POTENTIALLY UNQUALIFIED COMPONENT IN CERTAIN ALLEN BRADLEY TIMING RELAYS

**UPDATE - Report of potential 10CFR Part 21, Allen Bradley Timing
Relay Model 700RTC
Report No: P21-04302015, Rev. 2**

Part 21 Report No: P21-04302015, Rev. 2

Subject: **Update** - Report of potential 10CFR Part 21, Allen Bradley Timing Relay Model 700RTC – NRC Event Number 51030, Accession Number ML15134A016

Figure 2 - New design circuit board and CPLD that replaced the original component.

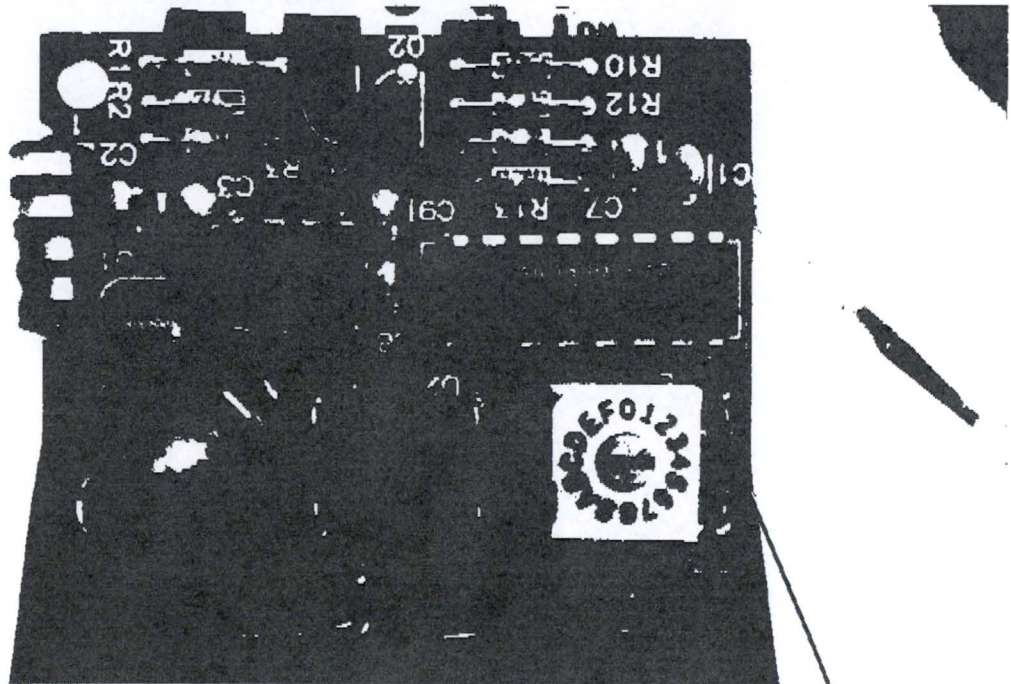
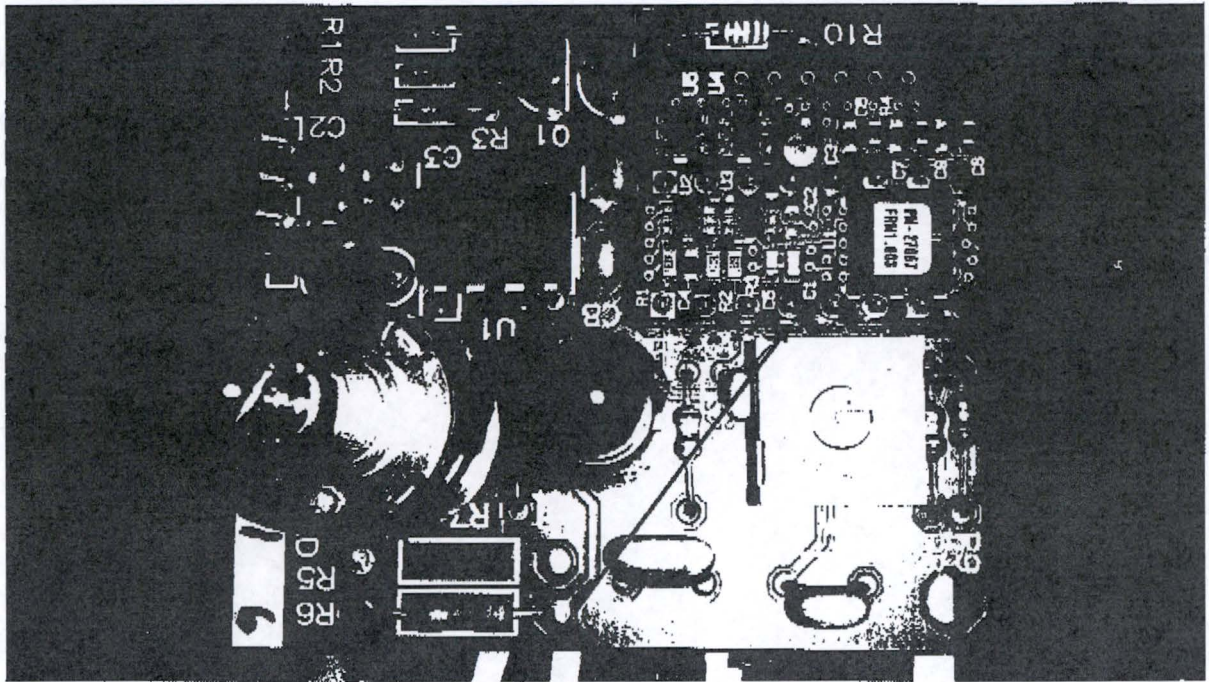
Between 2009-2010, Allen Bradley made a design change without changing the part number of the commercial relay or providing any documented evidence of a design change. The manufacturer specification data sheets maintain the classification that the relays are "solid state", which would imply that there are no digital devices installed in the relay. However, after inspection of the internals of the timing relay (Figure 2), it has been identified that the unit does contain a CPLD which meets the definition of a digital device under the guidance of NEI 01-01. See Figures 1 and 2 below:

Figure 1- Original qualified design (prior to 2009).
Relays supplied prior to 2009 are not affected by this issue.

The relays that are currently in stock at NLI have been placed on hold until after the units have been determined to be qualified for the specific application. NLI has completed the EMC qualification testing per the requirements of EPRI TR-102323 Rev. 4 for the following tests, as applicable: CE101, CE102, RE101, RE102, RS101, RS103, CS101, CS114, CS115 and CS116.

The results were satisfactory with exception of the following condition: During Conducted Susceptibility CS114 onto the power lines, with the timing circuit in operation, the instantaneous contacts exhibited chatter in the range of 2.6 MHz to 20.3 MHz. The unit requires a ferrite to be installed onto the input power lines of the relay with 3 turns through the ferrite core. In this modified configuration, the relay was not susceptible to Conducted Susceptibility and successfully passed the required test per CS114.
